From: Williams, Jeffrey
Sent: Wednesday, December 8, 2021 2:32 PM
To: anadv78@gmail.com
Subject: 705 Ridge Rd B21001968
Attachments: Plot plan memo for developed lots 10.21.21.pdf

Subject: Project name 705 Ridge rd Mount Airy MD 2771
Project site address 705 Ridge rd Mount Airy MD
Permit # B21001968 SDP # _____
Other information pertinent to this project _____

VENTURA RESIDENCE
705 RIDGE RD.
MT. AIRY MD. 21771

SITE INSPECTION SHEET

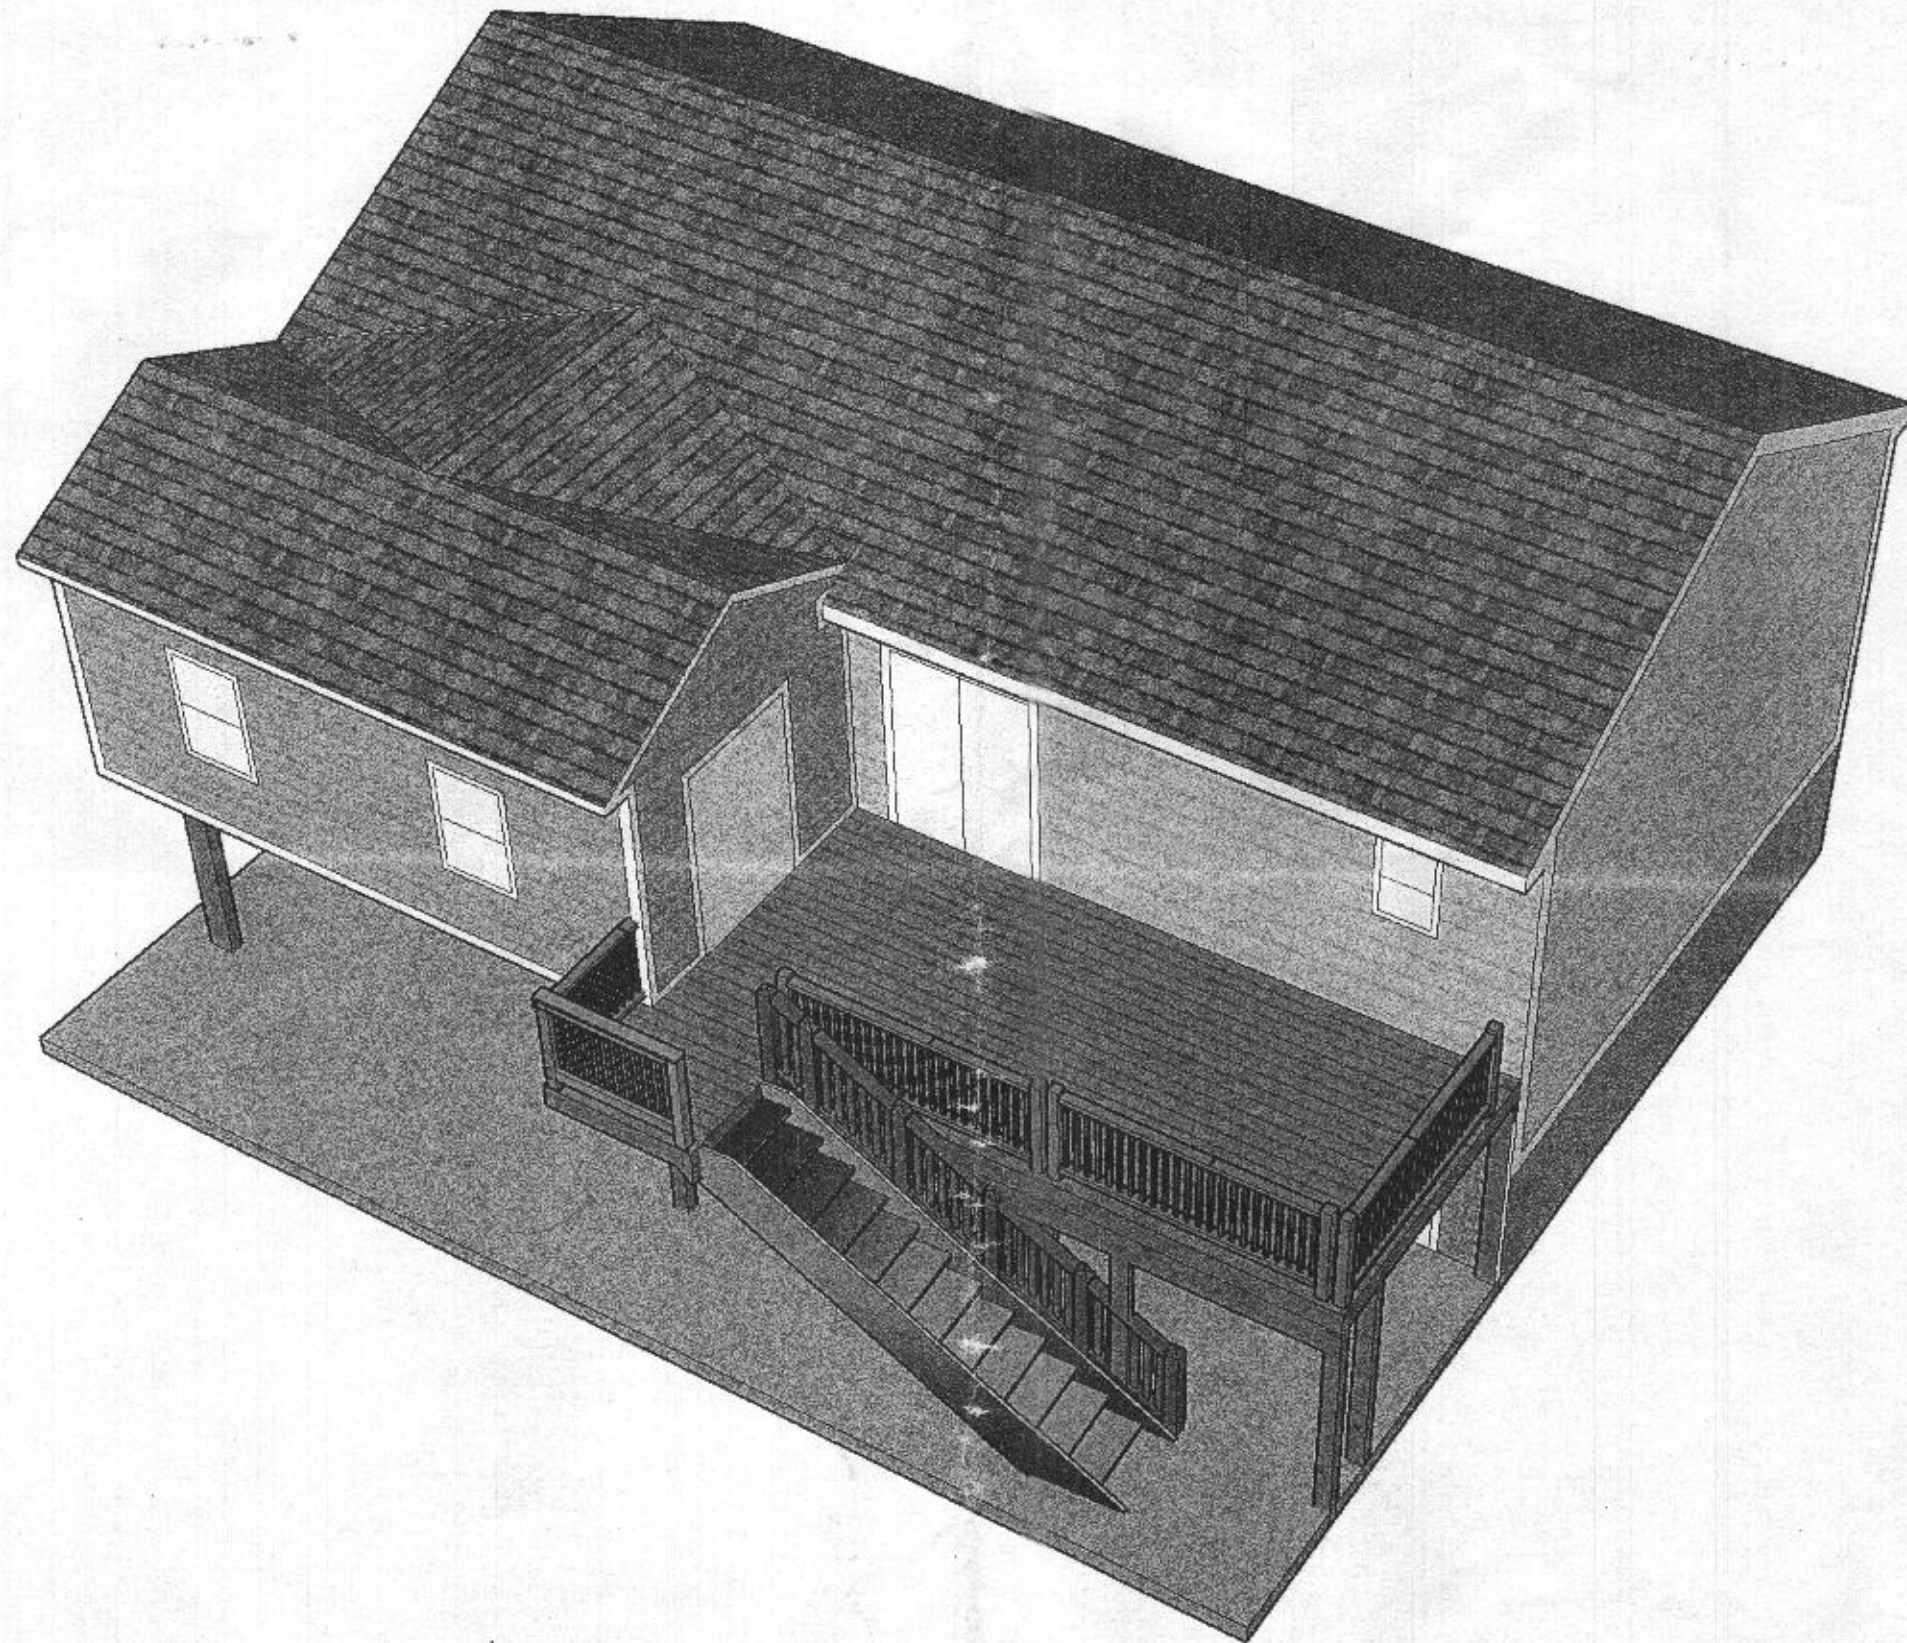
COMMENTS: Well and Septic appear to be in working condition. No signs of failure. Well needs two piece secure cap. Right now 1 piece unsecure. ST appears to have waste water level below inlet. Owner says it gets pumped every year. Don't know what disposal system entails. No records found. Owners don't know if drywell or trench.

PROPOSED SITE PLAN
1/16" = 1'-0"

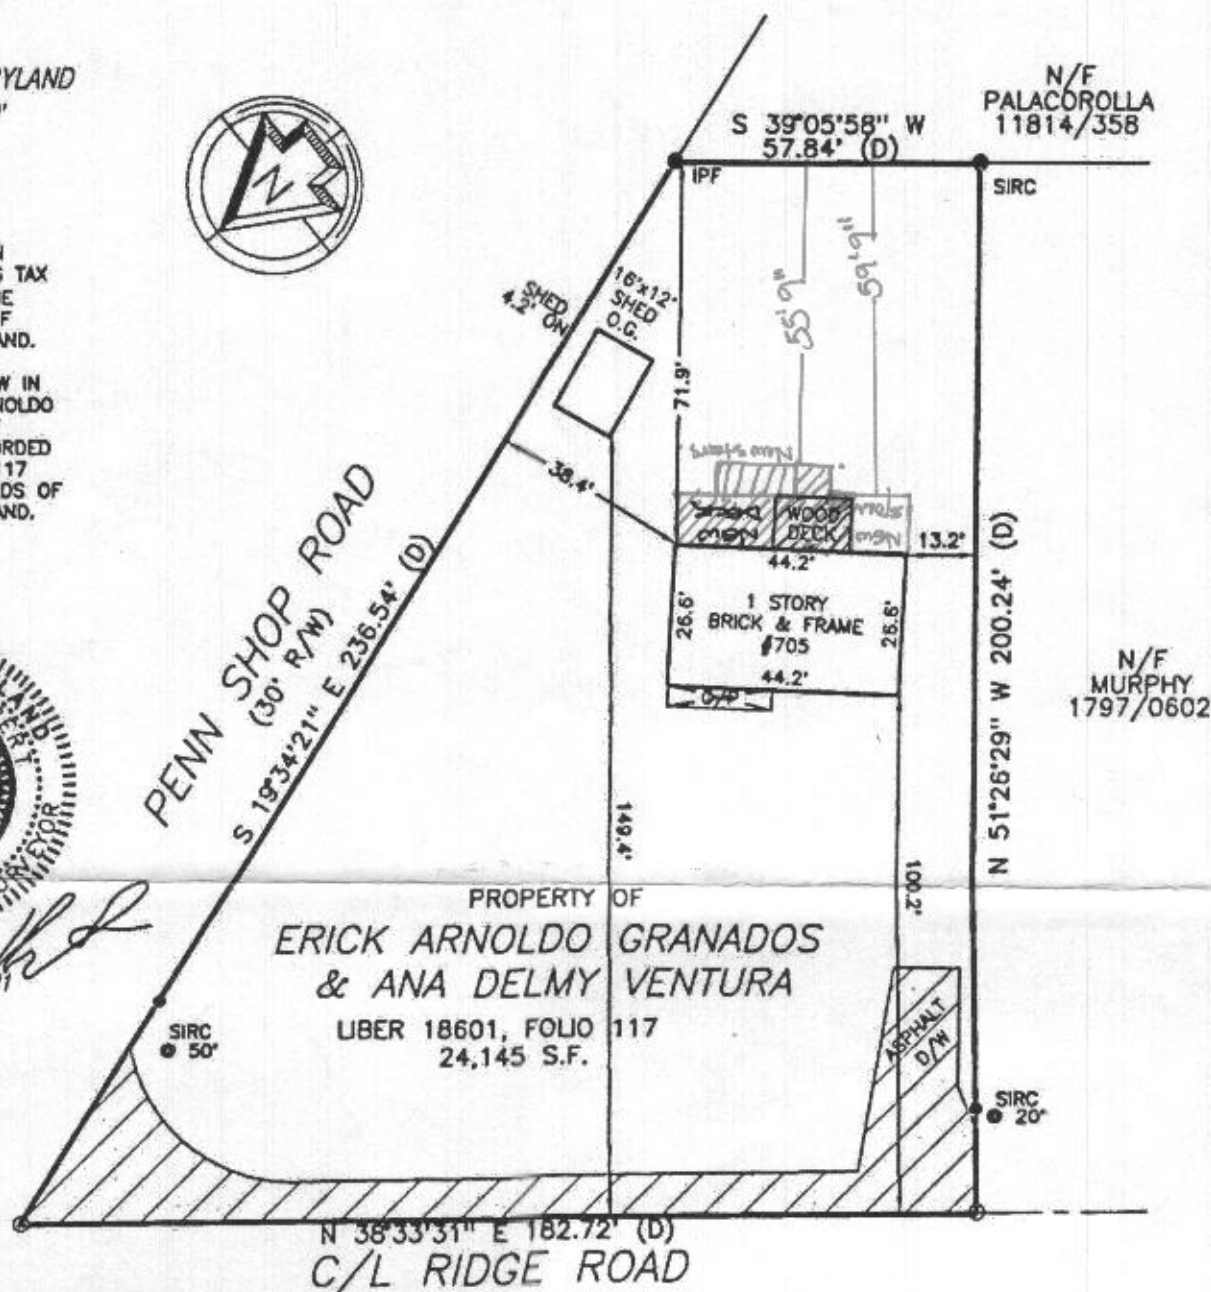
Hello. We received a revised plot plan for the above referenced building permit. We still need a plot plan that shows the locations of the well and sewage disposal system components and we need a floor plan showing the existing house and proposed addition. Please submit them so we can complete our review. Attached is a memo explaining the plot plan requirements. Thanks
